# LANDS OF SALAZAR

## *Drainage Management Plan*

October 2006  
Revised November 13, 2006

**Re: Lands of Salazar Drainage Management Plan**  
**Engineer's Stamp dated 12-20-06 (N9/D11)**

**FIGURE 1 Zone Atlas Map N-9**

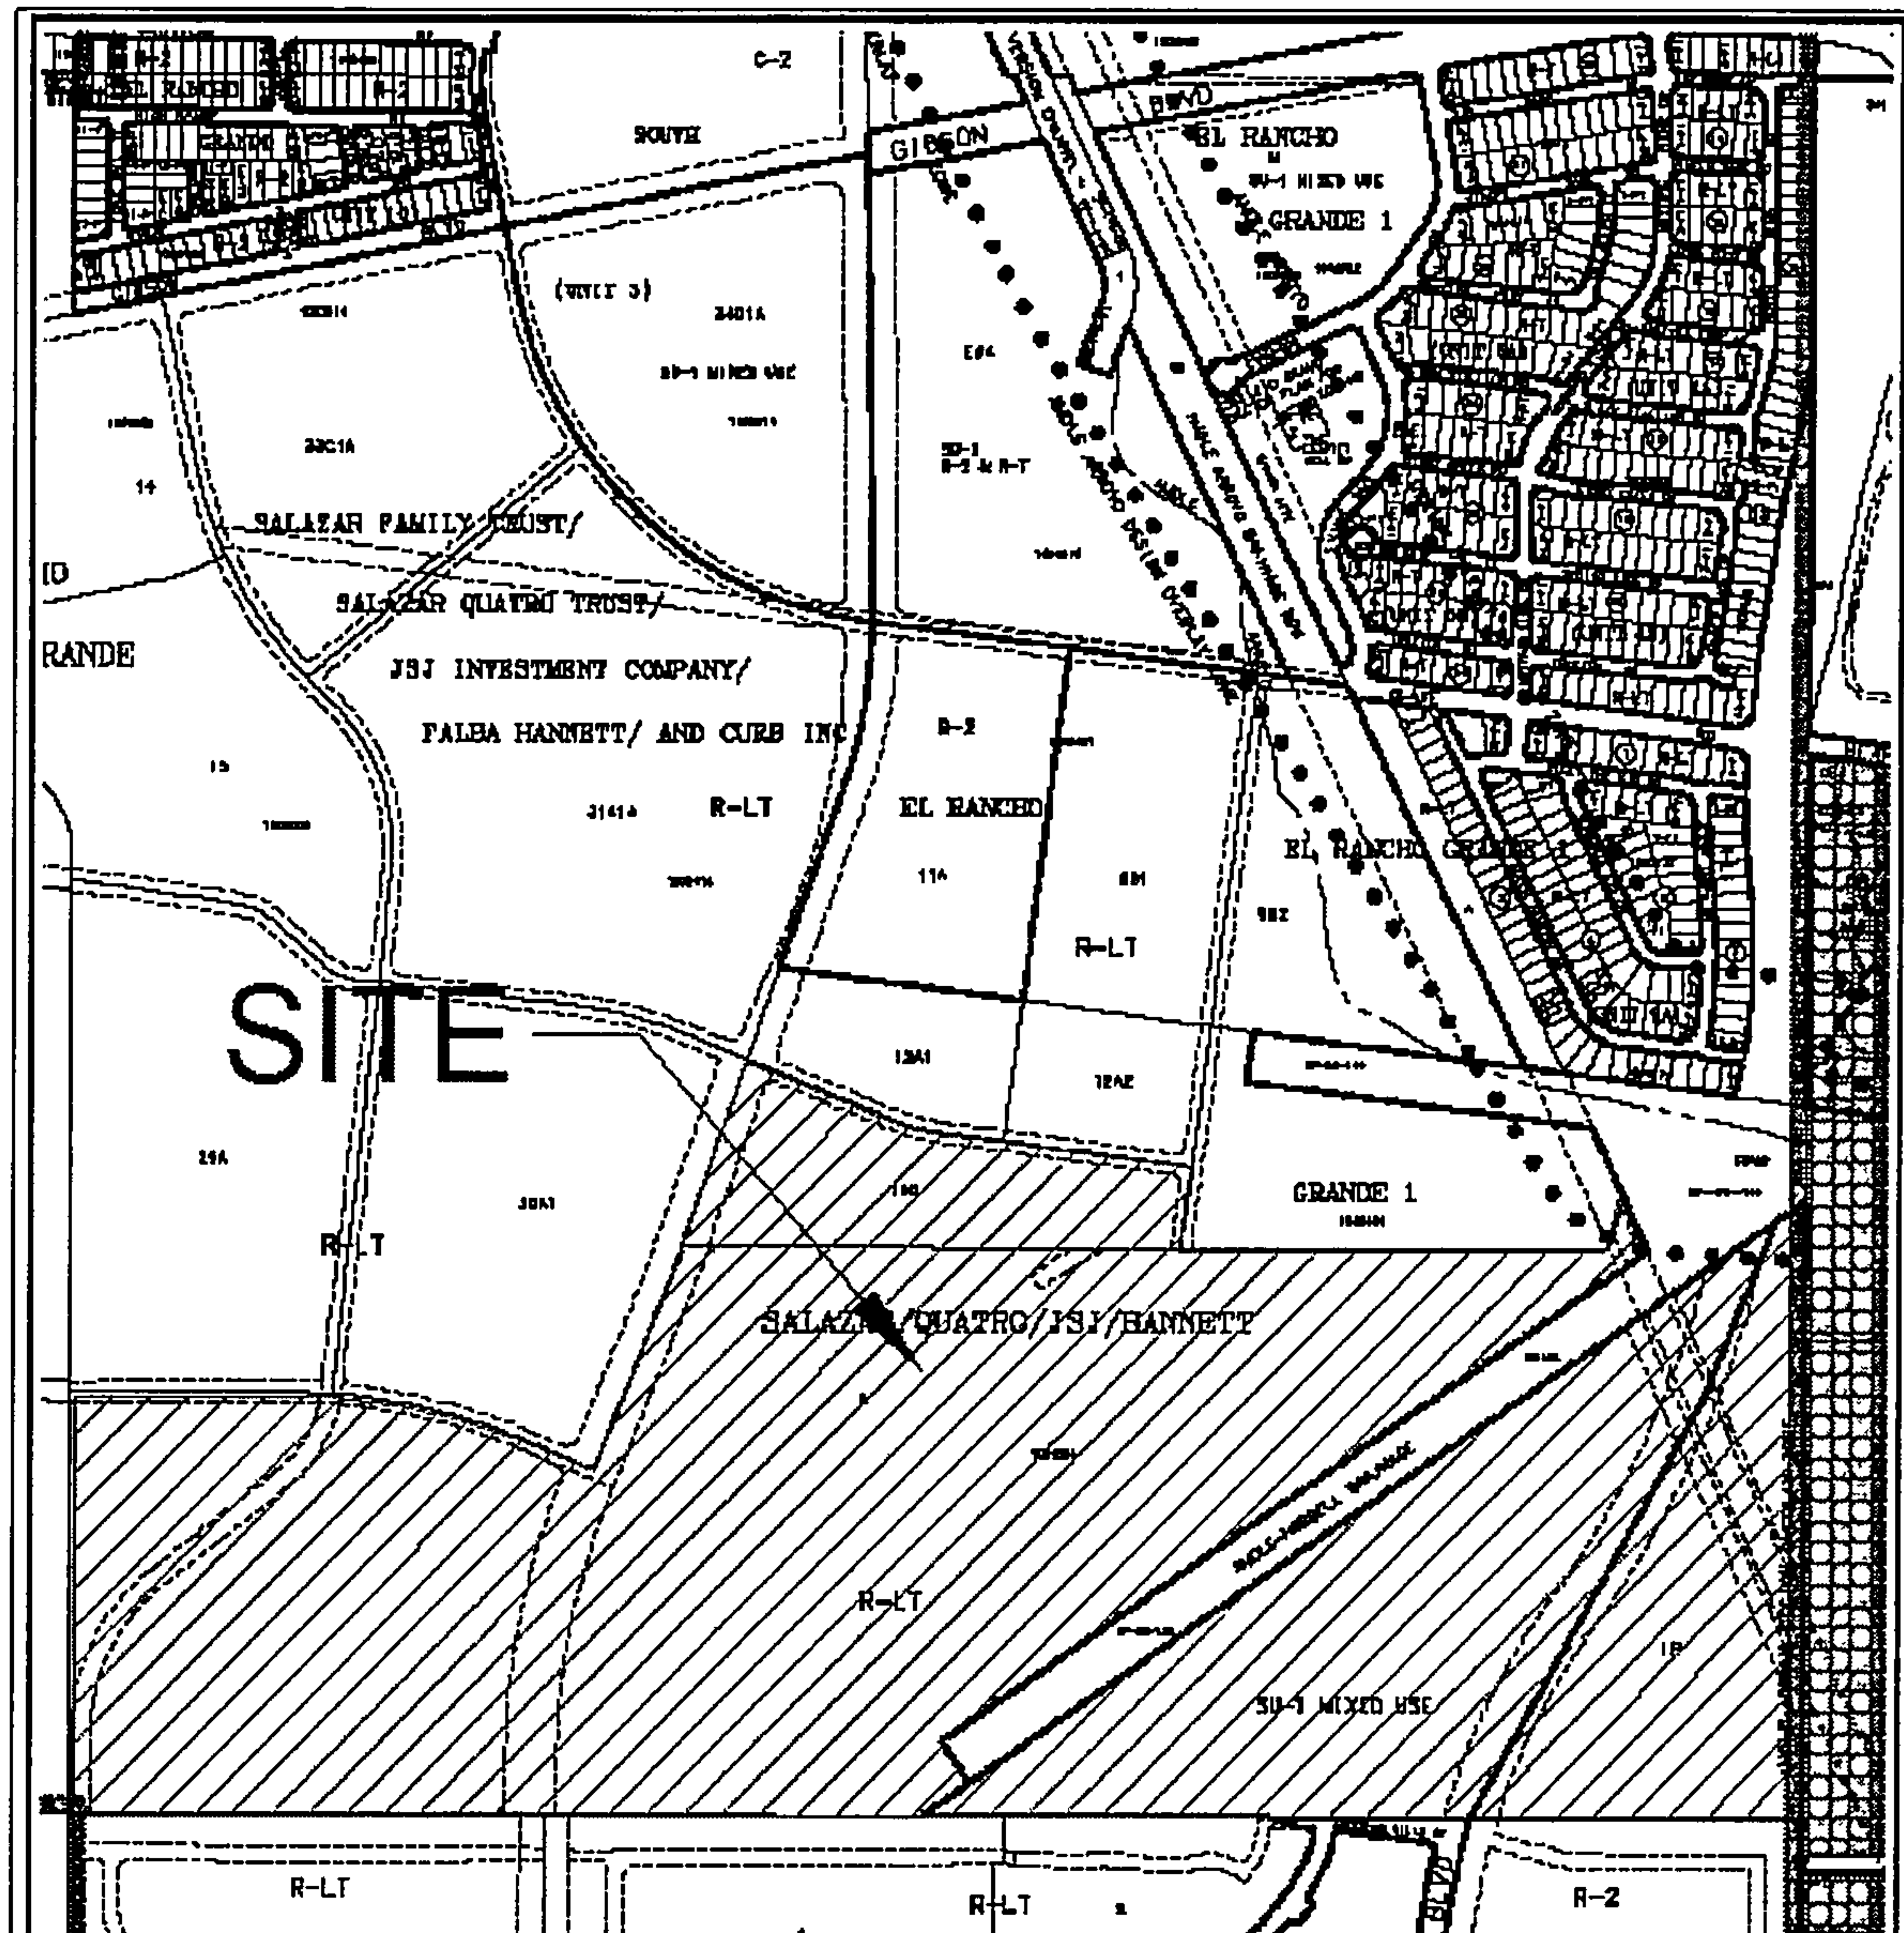
- Would it be possible to provide a plan that wasn't as dark and also to improve the Vicinity Map and FEMA Map so they are legible?

TRACTS 29, 30, 31  
DRAINAGE MANAGEMENT PLAN  
FIGURE 3A  
**PROPOSED INTERIM  
CONDITIONS**

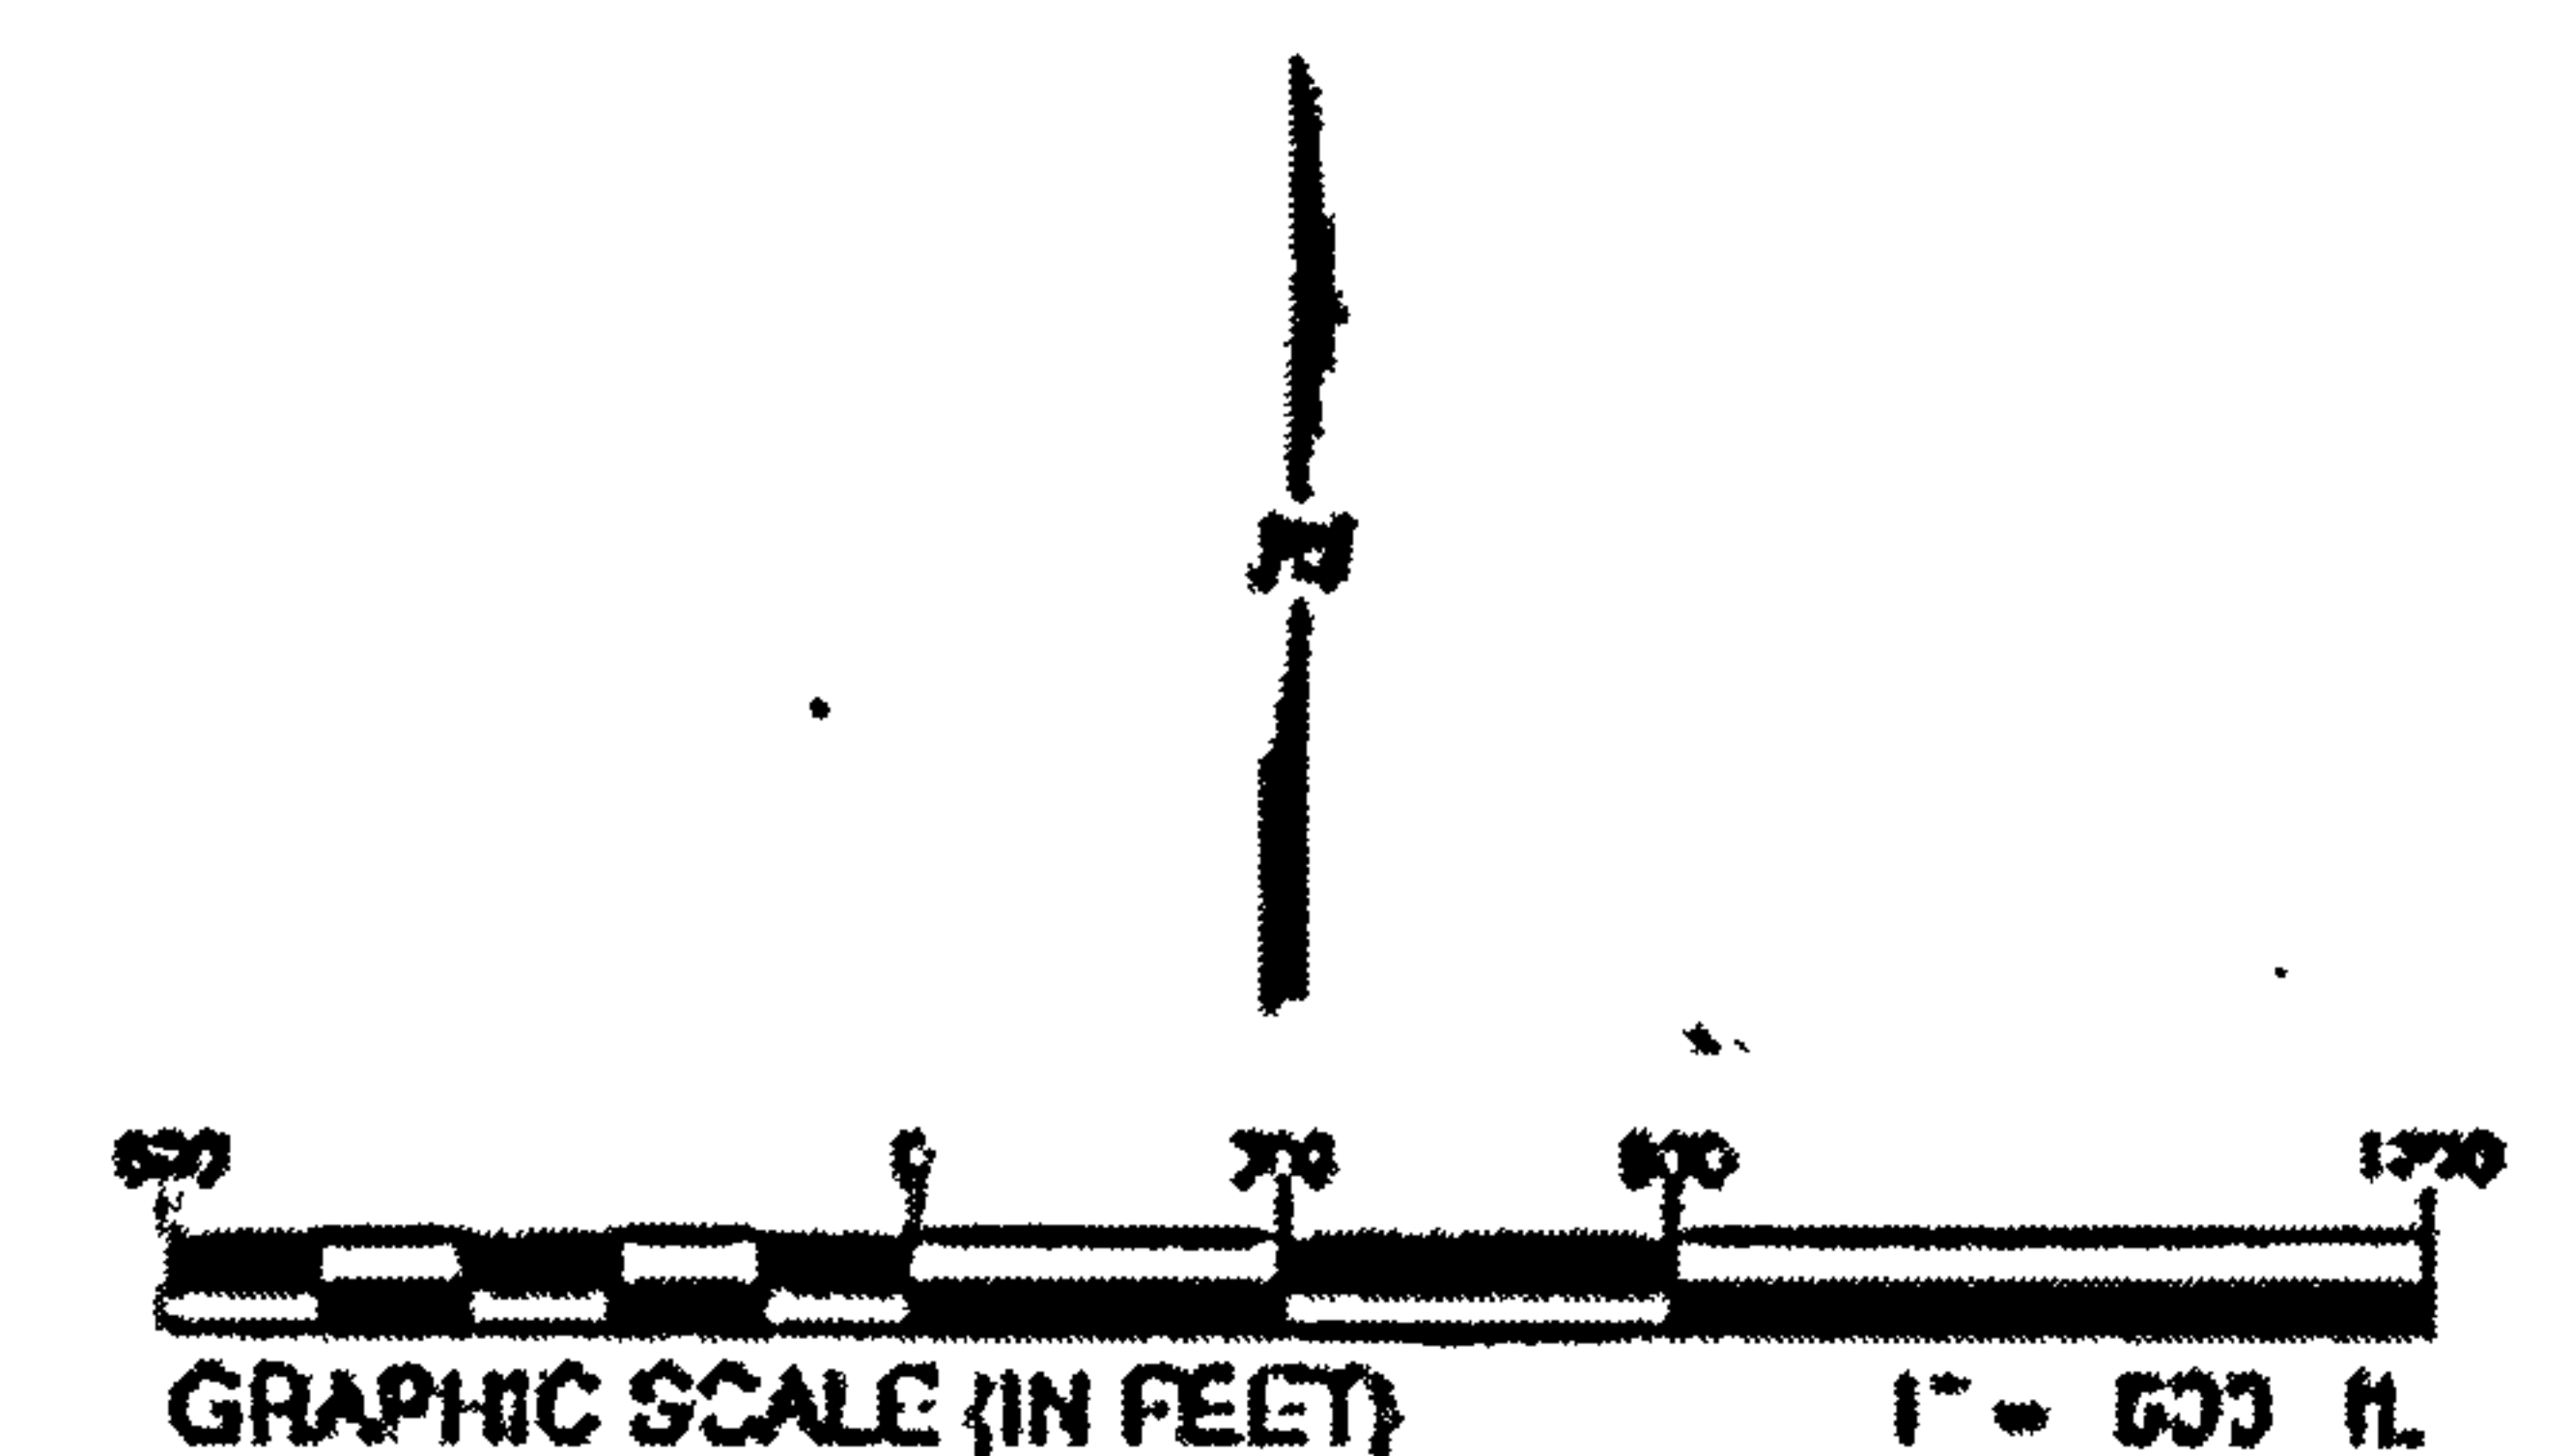
- Add excerpt from Arrowwood justifying Basins 1, 2, and 4 draining into Colobel and 98<sup>th</sup>.
